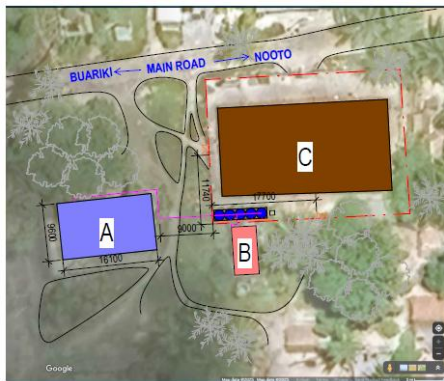
Nooto 1, Nooto 2 and Nooto 3 have the same scope shown on the design- pls refer to sheet # A03, A05 and A07. But the estimate table gives a different scope to price against.

Could you please kindly confirm which document should take precedence for pricing purposes, or alternatively provide clarification on the discrepancies identified?

2 BUARIKI PROPOSED SITE PLAN
Scale: 1 : 300

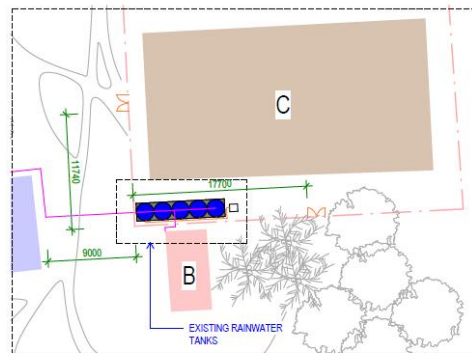
Please kindly confirm that the new Fence will be installed along the perimeter of Block C- Mwaneaba. Otherwise just around the existing rain water tank?
